SERVICE BULLETIN

PRODUCT: GRAIN VAC

MIDDLE AUGER

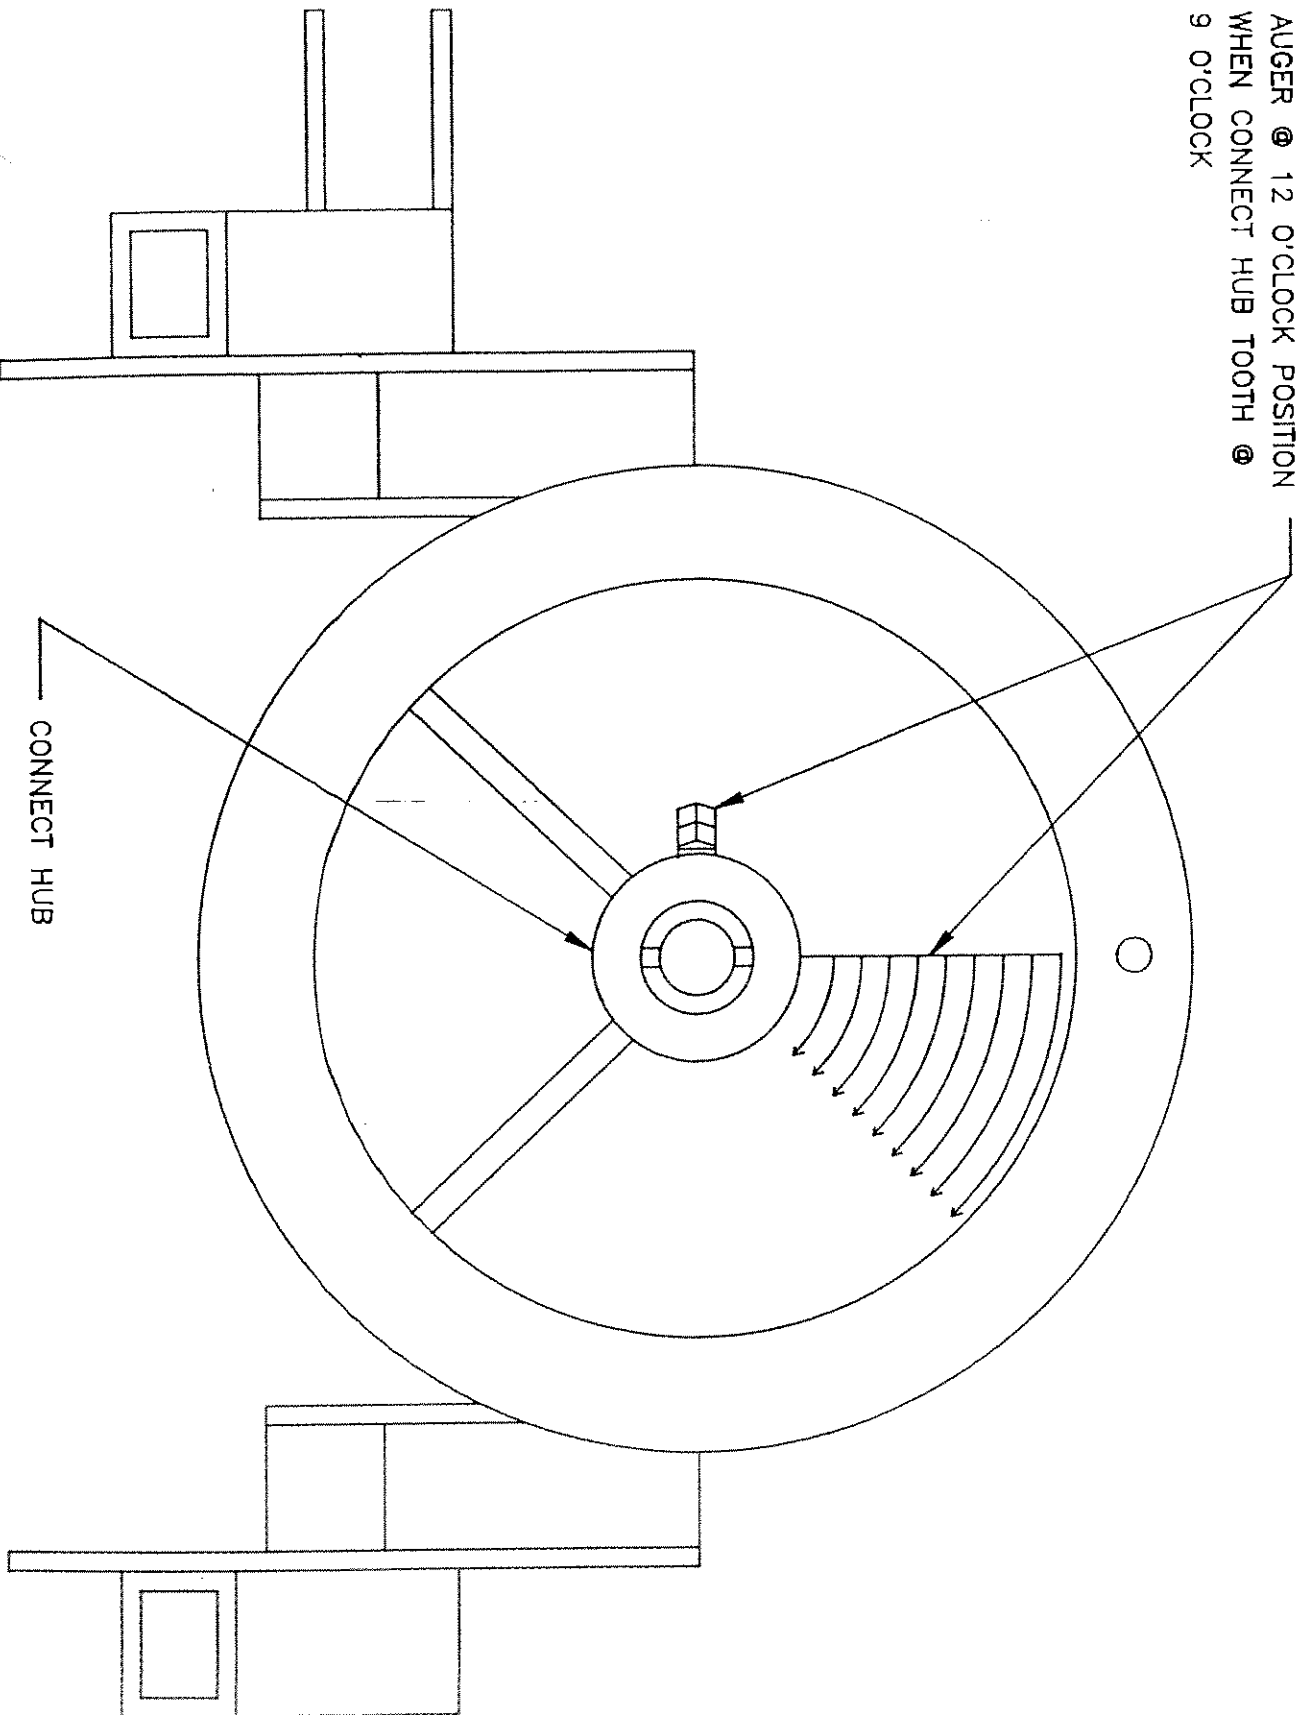
Also, double check the connector hub to ensure that it is set in time. Turn the auger so that the cutoff is at the top (12:00 position) - the back tooth on the connector hub should be at the 9:00 position. If this setting is out, you may have plugging problems in your auger.

These procedures are necessary to correctly align the auger, and should be done whenever the augers are removed for replacement or repair. See drawing for details.

SUBJECT: MIDDLE AUGER TUBE 38-104023

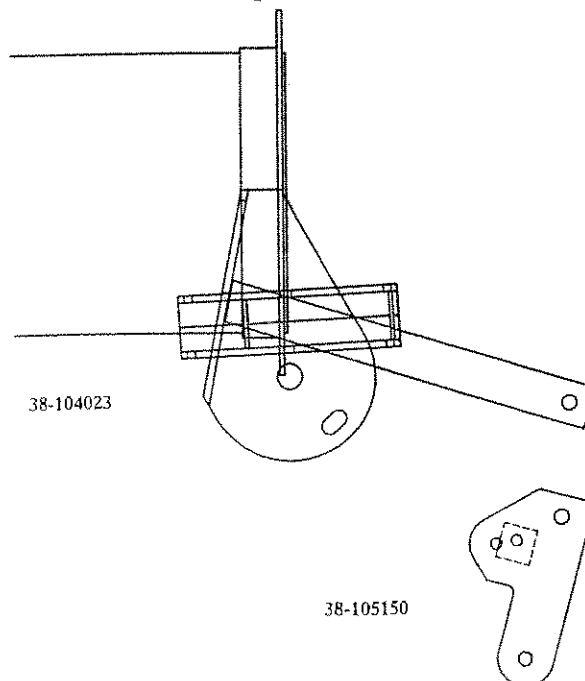
We have changed the 1026 middle auger clevis to allow the customer to adjust the amount of force required for moving the unloading auger in and out of transport positions. Now when your customer orders part # 38-104023, he will require the update kit, part number 38-105150. See drawing for details.

SUBJECT: DUMPER REPLACEMENT

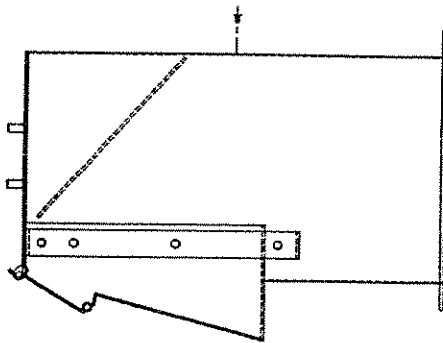
We have developed a new dumper with a replaceable ultra-high molecular weight polyethylene liner, which increases life over our original steel configuration. If your customer wants to replace his 1026 dumper, he will require the new assembly, part number 38-105165-7, along with the adaptor kit, part number 38-104781. See drawing for more information.

SUBJECT: CONNECTOR HUB

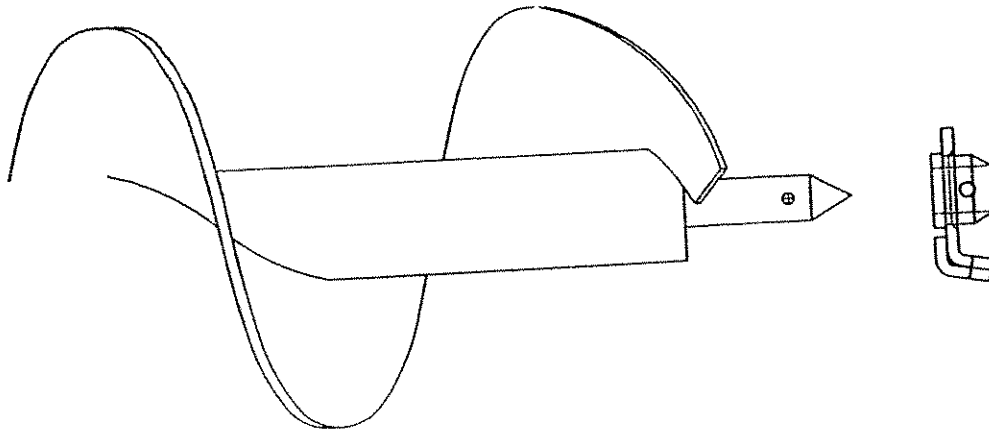
We have increased the diameter of the auger drive connector hub's steel pin from a 1/4" to 5/16". When your customer orders a Connector Hub, part number 38-104066, he will have to drill out the shaft ends of his middle auger, part number 38-104061, to accommodate the new sizing. See drawing for more details.

SUBJECT: AUGER LIFT SPRINGS ADJUSTMENT

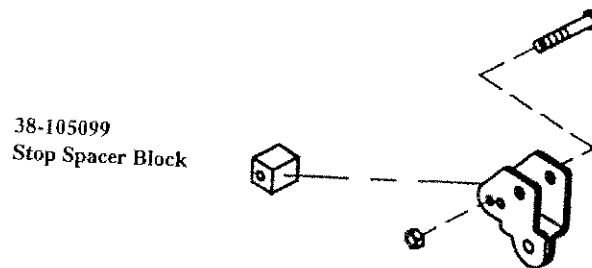
The stop spacer block, part number 38-105099 can be reset as follows:

1. Elevate the auger
2. Loosen the 3/8x2" bolt (do not remove)
3. Rotate the block by 1/4 turn either way
- CAUTION: WATCH OUT FOR YOUR FINGERS!**
4. Tighten the bolt

1026B GEARBOX (PLUG & VENT LOCATIONS)

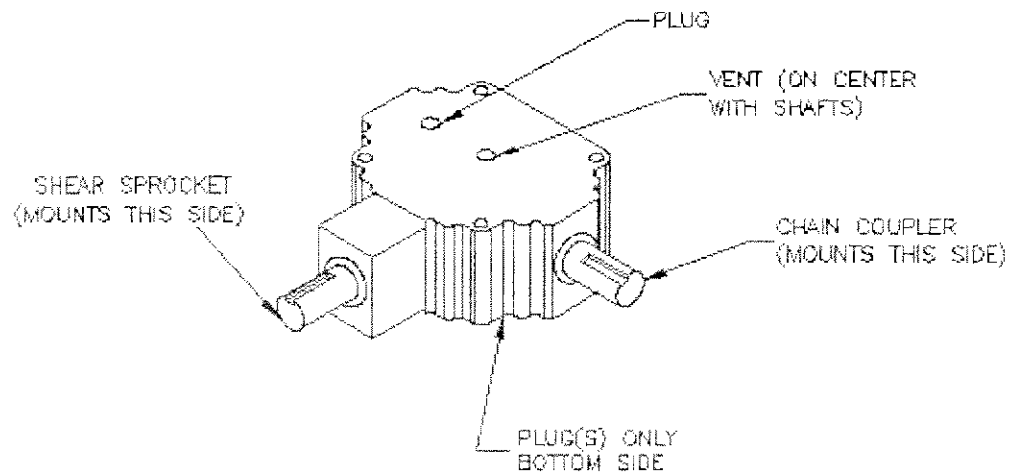
To affected Rem Grain Vac Dealers. We have had one incident where the gearbox plugs on the 1026B Grain Vac were reversed. We have narrowed down the cause to a factor that may have affected the first 1026B production run in 1999. We feel it is in your customer=s best interest to ensure that the machine you have purchased (see serial number below) is not affected. Please check the plugs according to this drawing: the vent plug should be on the highest level, and the solid plug on the lower. See attached diagram for details.

SERVICE BULLETIN FIGURE 1

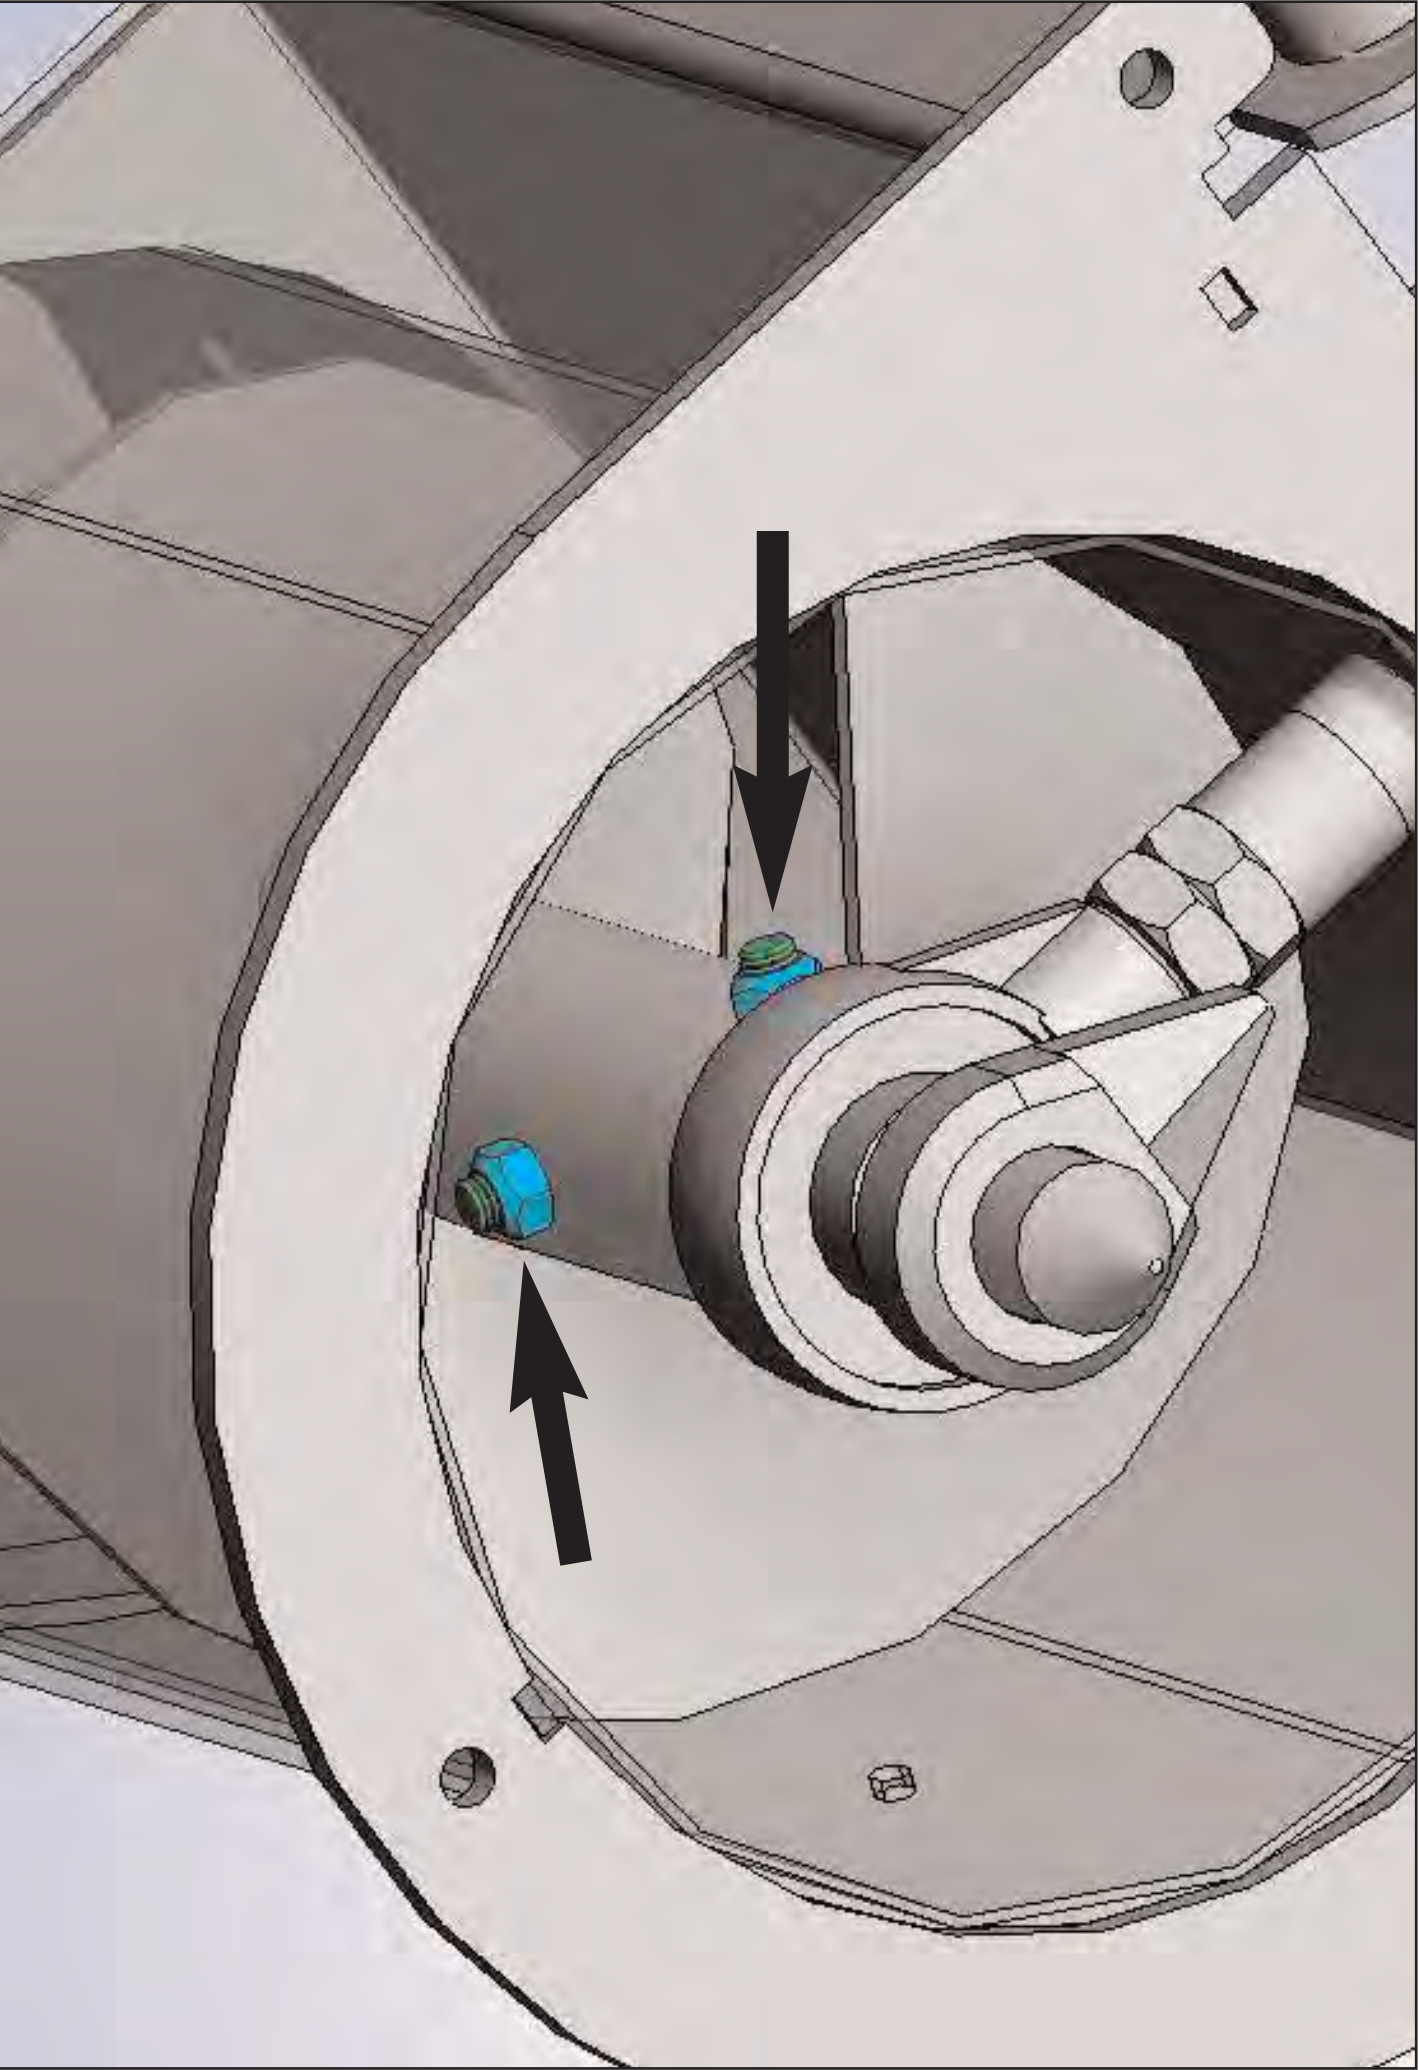
In some cases the bolts holding the drive shafts in place on the auger flyting have loosened.

Please check to be sure that they are snug. Put a center punch indent at the edge of the threads and nut to help out in the locking of the uni-torq nuts.

MAINTAINING O-RING CHAIN

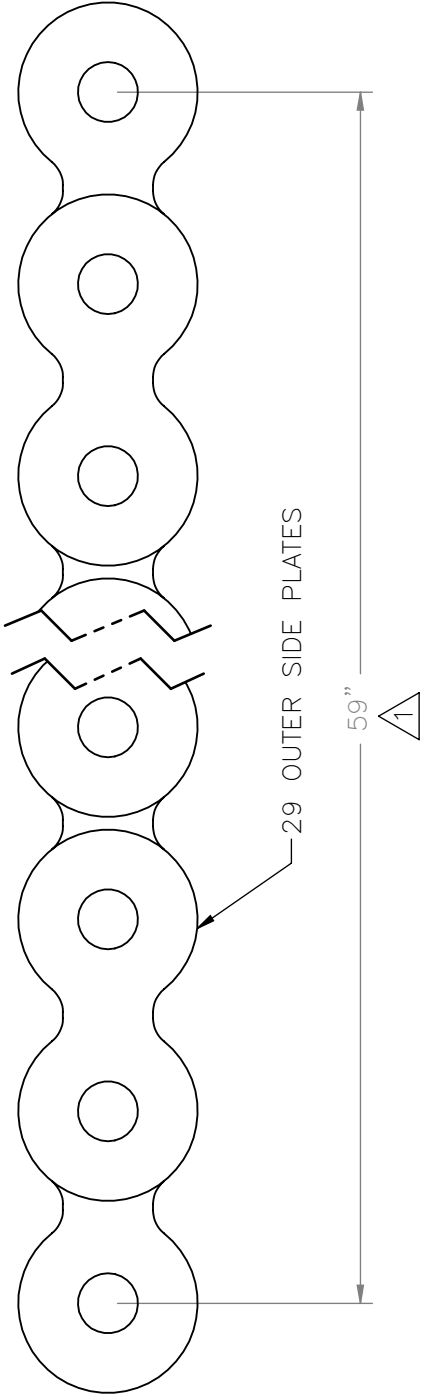
NOTE: COMPRESS THE LINKS JUST ENOUGH TO INSERT THE COTTER PIN. OVER COMPRESSING WILL DAMAGED THE O-RINGS AND THUS RESULT IN CHAIN FAILURE

REMOVE OLD "OIL DAILY" DECAL
CLEAN GUARD SURFACE TO ENSURE OIL AND DIRT FREE
APPLY NEW DECAL. (9005-55-0182)

Figure 1

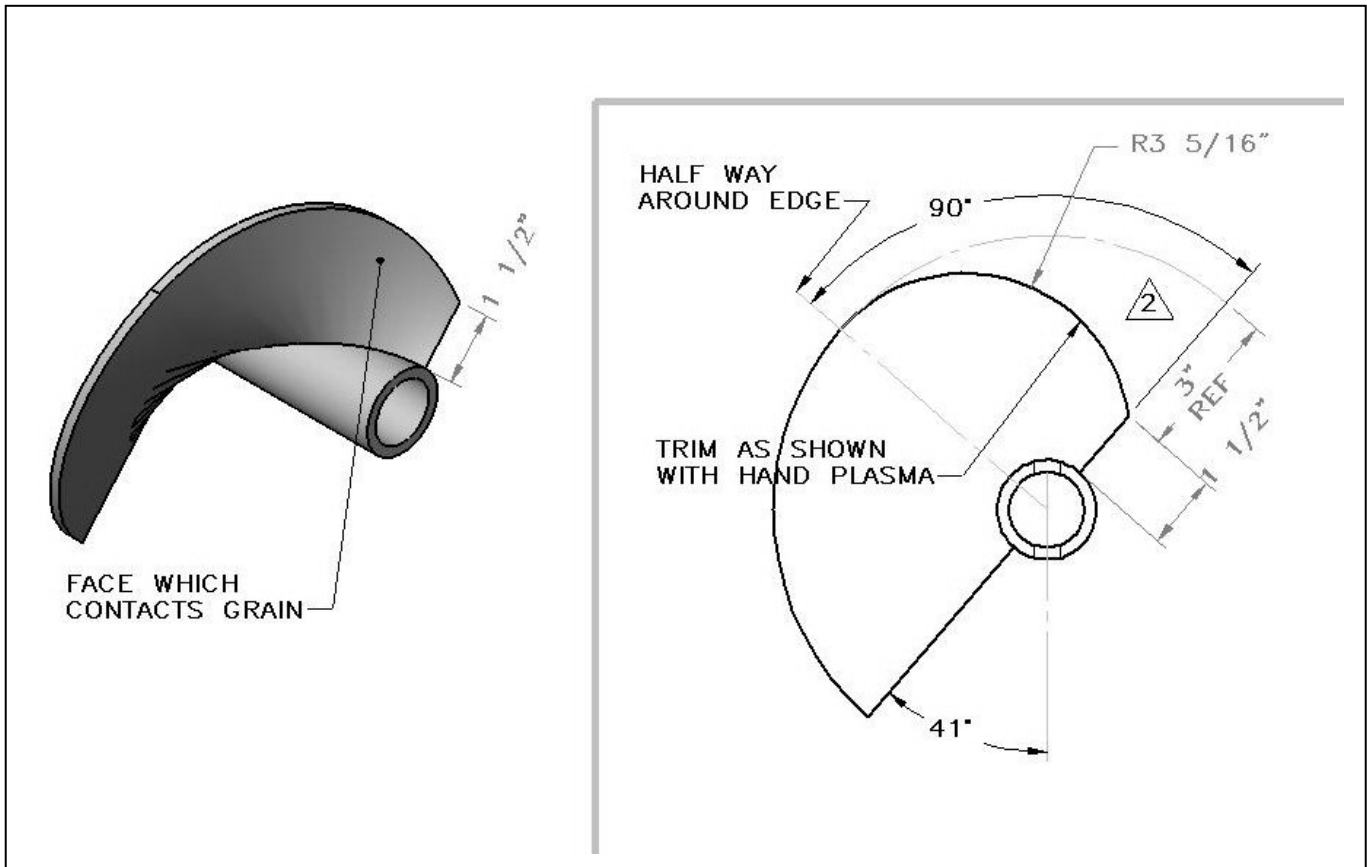
The attached drawing indicates which portion of the short LH flighting to remove. Using a hand torch or grinder, it may be possible to eliminate the indicated material without removing the flighting from the auger tube, although caution should be used, along with all appropriate personal protective equipment and safety precautions.

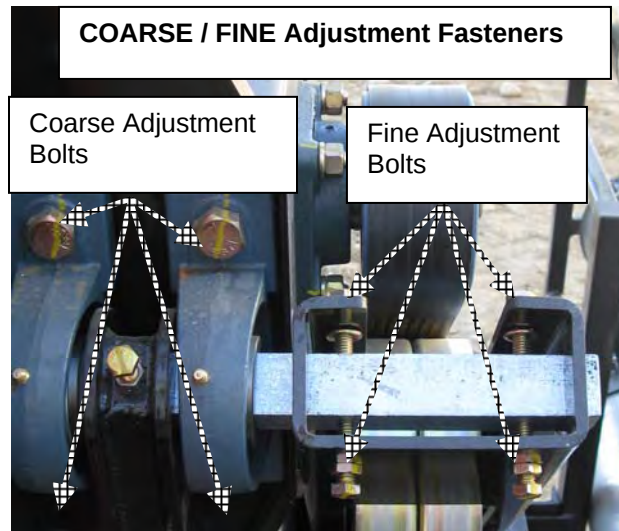
3. Open or remove the rear guard and, observe the blower drive belt from the inlet side of the vac. Rotate the assembly by hand in the normal direction of travel and note whether the belt, WHERE IT PASSES OVER THE IDLER PULLEY, may ride towards the FRONT or the REAR of the vac. This is most easily observed by **sighting over the tight side of the belt**, and noting a curve or "bow" in the belt on the slack side where it passes over the pulley. See photos below.

Adjustment for Belt Riding Towards REAR

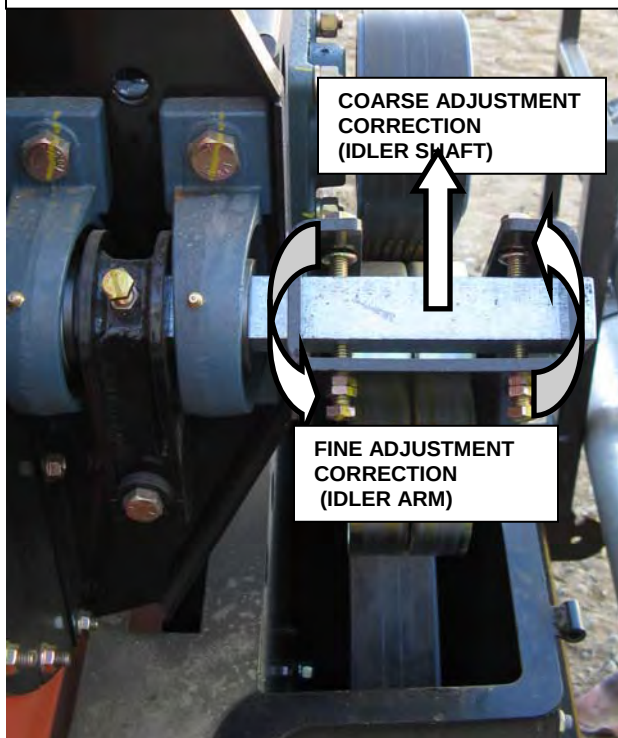
6. If the belt is misaligned as shown, first make the FINE adjustment. If the belt remains misaligned in the same direction, then complete the COARSE adjustment. After completing the coarse adjustment, it may be necessary to repeat the fine adjustment.
7. Following alignment, retighten all fasteners, and rotate the assembly in the normal direction of travel to ensure the belt, where it passes over the idler pulley, is not visible to either side of the belt on the tight side, as per the first photo.
